Notice of Allowability

10/800,514

EXAMINER'S AMENDMENT

FIGURE 1

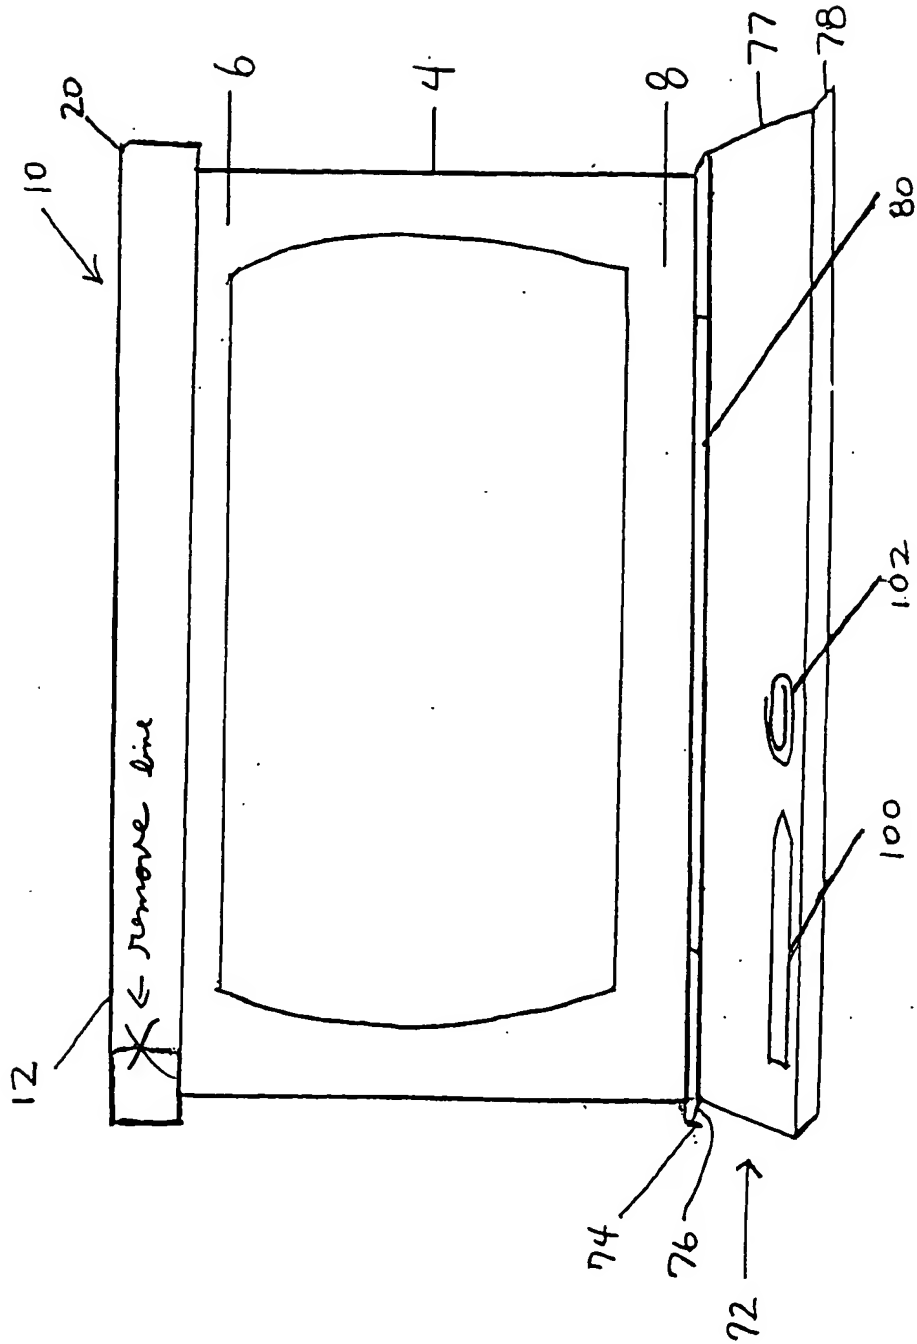
The following changes to the drawings have been approved by the examiner and agreed upon by applicant: Figure 1 and Figure 6, element 12 will be shown as a rectangle only by deleting the vertical line within the rectangle (see exhibit A and exhibit D) so as to eliminate the confusion that the C-shaped channel 12 might be of a tube construction. Figure 2, line on plate 50 to show the bent will be provided (see exhibit B). Figure 3, the upturned lip on the bottom flange 50 shall be shown (see exhibit C). In order to avoid abandonment of the application, applicant must make these above agreed upon drawing changes.

EXHIBIT B

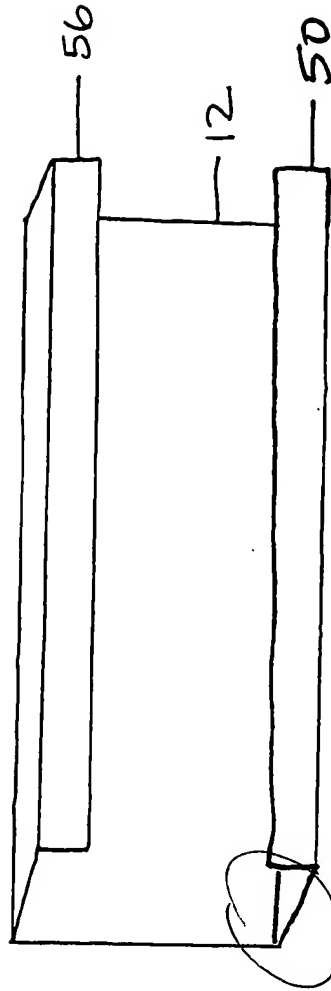
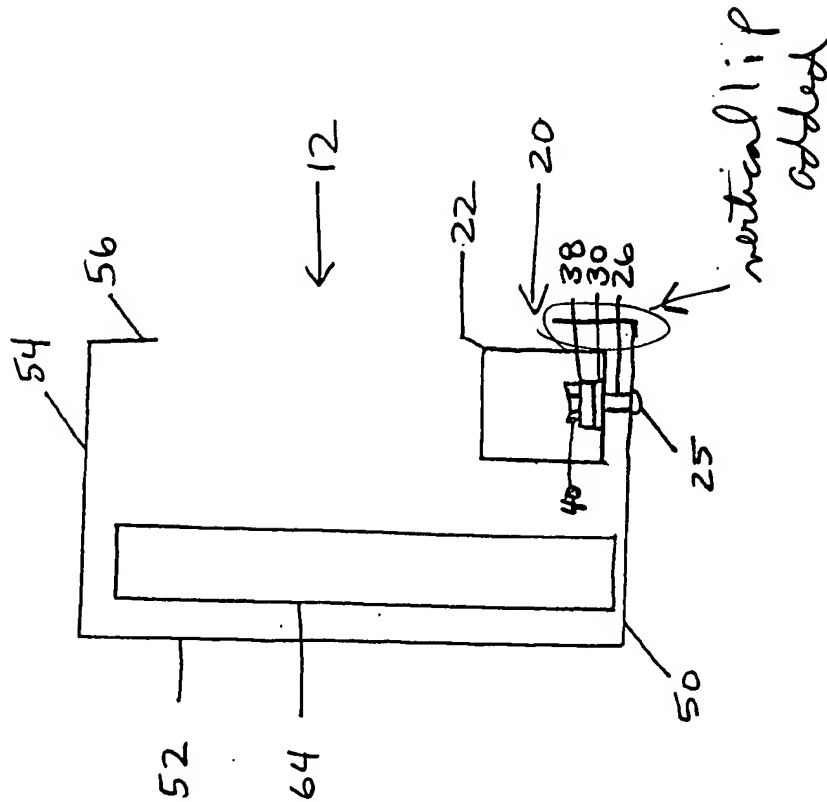
add line

FIGURE 9

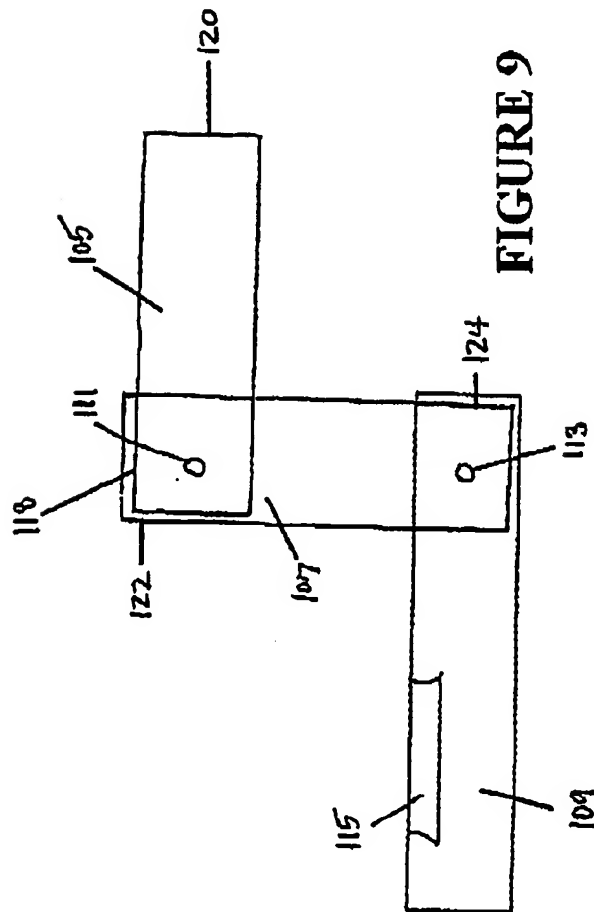
Propose drawing correction for figure 9 filed 12/21/2005 has been approved while proposed drawing correction filed 12/21/2005 for figures 2 and 3 are not approved.

FIGURE 3

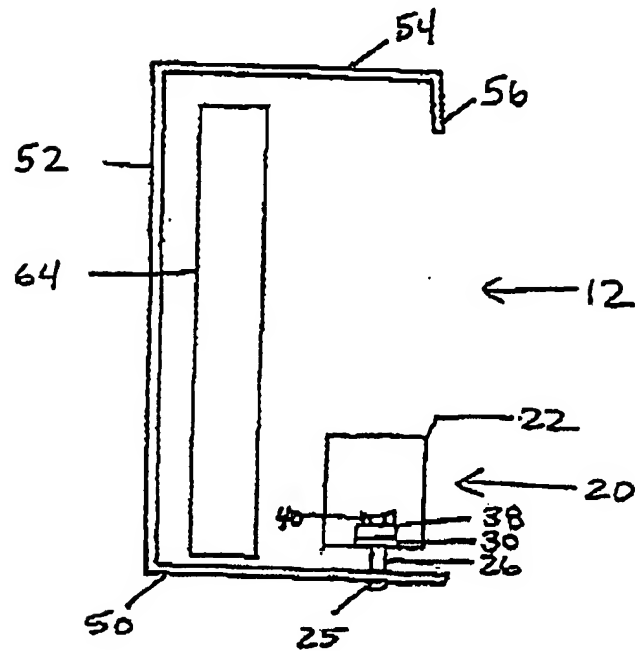
not approved
KAC
2/15/06

FIGURE 2

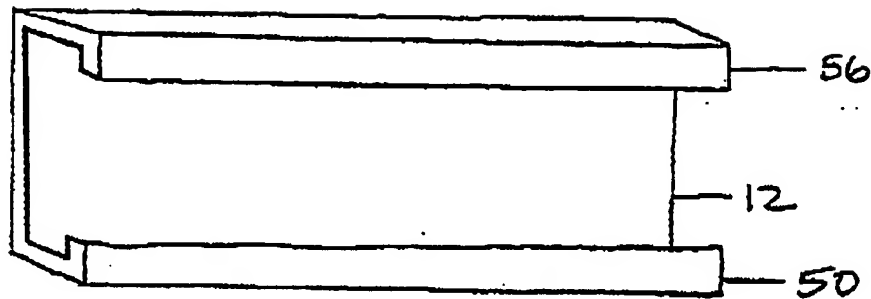
not approved
KAR
2/15/06
